**Exhibit C – Redlined from the May 28, 2024,  
Town Council Meeting**

Case No. ZONE-24-0001

**EXHIBIT C  
Planned Development Standards**

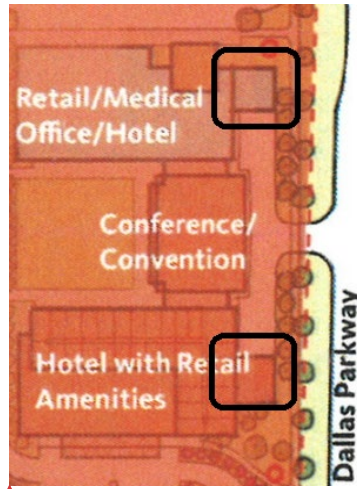
- ~~a.~~ Along the Dallas North Tollway (Dallas Parkway): Fifty (50) foot front yard with a thirty (30) foot landscape buffer. In Phase 1A, the front yard setback and landscape buffer may both be thirty (30) feet in the service areas outlined in the graphic below, provided that these areas are heavily landscaped, including berms:
